Application no: R3.0138/21

Location: A linear site comprising a corridor between the A34 Milton Interchange and the B4015 north of Clifton Hampden including part of the A4130 east of the A34 Milton Interchange, land between Didcot and the former Didcot A Power Station and the Great Western Mainline, land to the north of Didcot where it crosses a private railway sidings and the River Thames to the west of Appleford-on-Thames before joining the A415 west of Culham Station, land to the south of Culham Science Centre through to a connection with the B4015 north of Clifton Hampden.

Transport Development Control

Recommendation:

Figure 2.3.3: OFF3 Available Stages

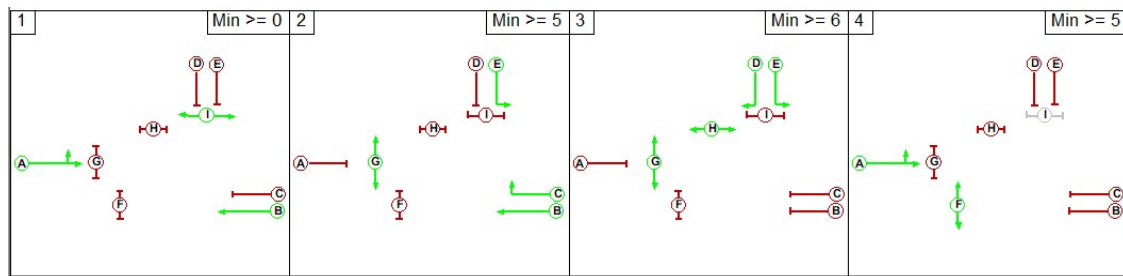
The modelled sequence was 1-2-3-4. This would be the most robust sequence, as it assumed that Phase F is called every cycle (Stage 4). However, if Phase F demand was expected to be low, then the model would provide unrealistically pessimistic results due to a significant reduction to westbound traffic (i.e., if Stage 4 were not demanded, the junction would move to Stage 1 and provide green to Phase B).

Figure 2.6.4: OFF6&7 Model versus Specification Intergreens

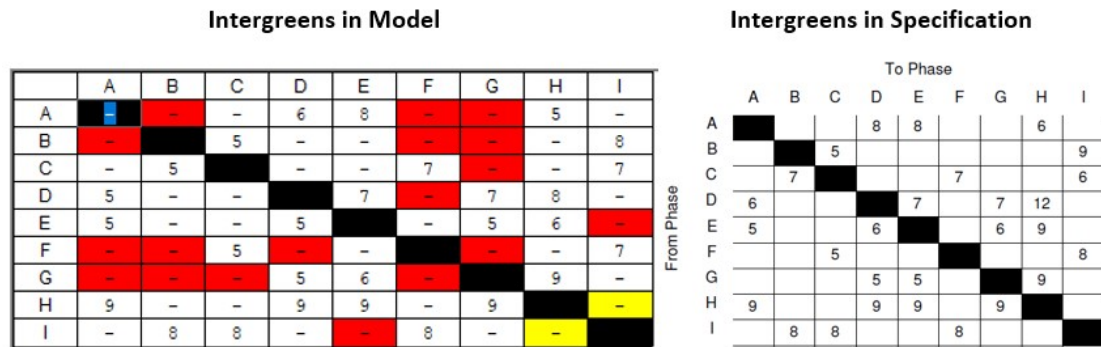
- 2.6.11 Many of the intergreens used in the model were lower than those within the controller specification. A comparison between them is shown in **Figure 2.6.4**.

Figure 2.12.1: OFF13 Lady Grove / Sires Hill Layout

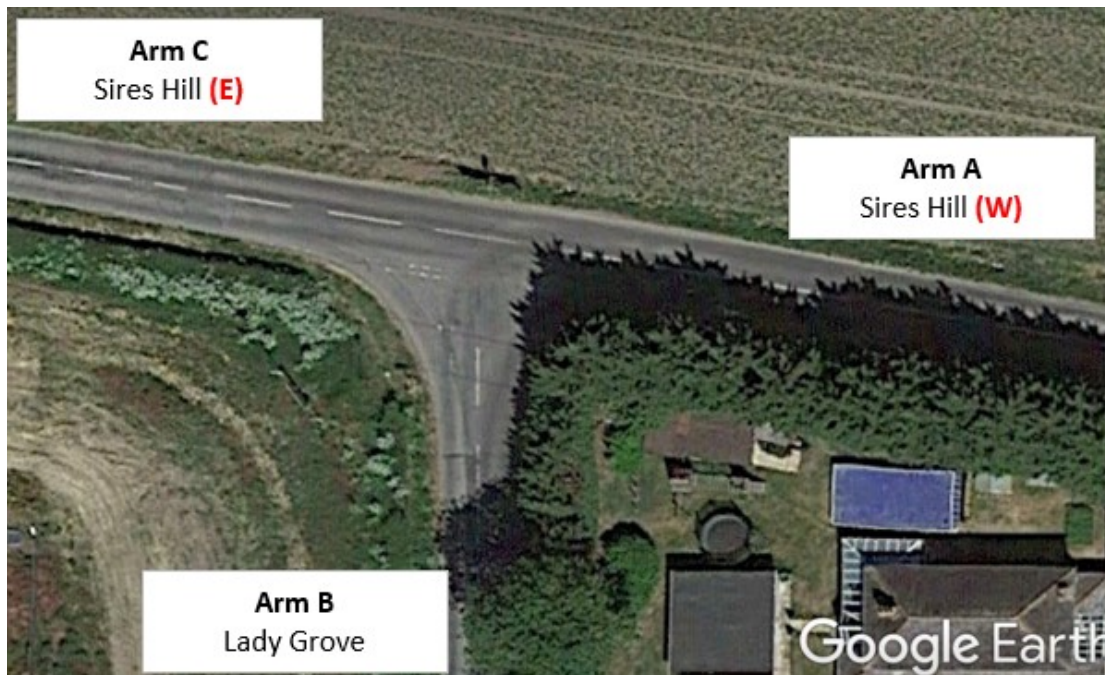
- Receipt and review of additional requested technical information, prior to providing our final comments.
- The JCT audit highlighted a discrepancy in the modelling at the Ladygrove / Sires Hill junction (OFF13). The Arm names inputted by the modeller, indicate that Arm A was the WESTERN arm and Arm C was the EASTERN arm. However, as PICADY will assume Arm A is to the east and Arm C to the west, and thus the traffic flow assignment will be incorrect. OCC assume this is a labelling error and requires confirmation.

The arms shown in the above Figure are the assumption the model makes when assigning traffic flows. However, the modeller input Arm names that indicate Arm A was the WESTERN arm and Arm C was the EASTERN arm. This may simply be a labelling error in which the modeller mixed up west and east. However, if the modeller intended Arm A to be the western arm, and Arm C to be the eastern arm, then all modelling results will be incorrect, as PICADY will not make the same assumption. This can be checked by referring to the traffic flow matrices used in the model, and confirming whether the traffic flows to/from Arm A correctly represent traffic to/from the east, and traffic flows to/from Arm C correctly represent traffic to/from the west.

Figure 2.15.4: SCH2 Intergreen Comparison

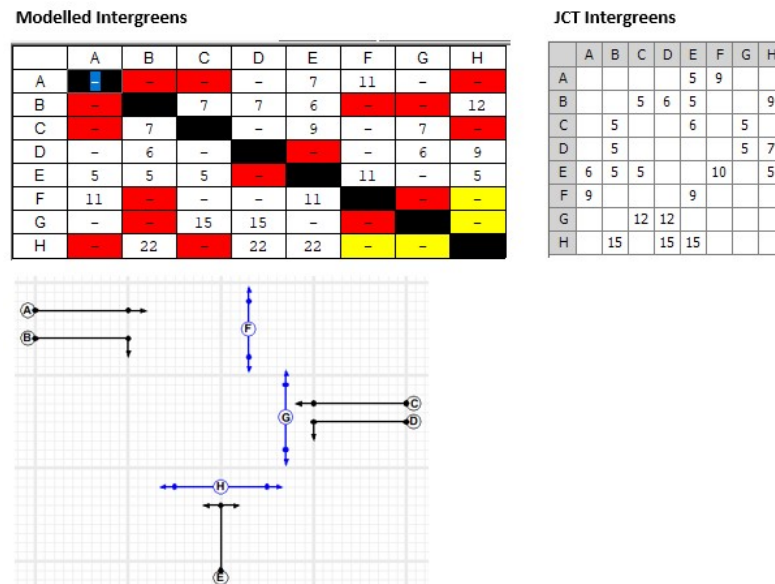
- 2.15.7 JCT measured the intergreens using quickGreen, based on guidance in Chapter 6 of the Traffic Signs Manual. The full quickGreen output is included in Appendix B. **Many of the intergreens used in the model were significantly higher than those measured by JCT.** The reason for this was unknown, but could result in the model predicting less capacity than would be expected. A comparison of the intergreens is shown in **Figure 2.15.4**.
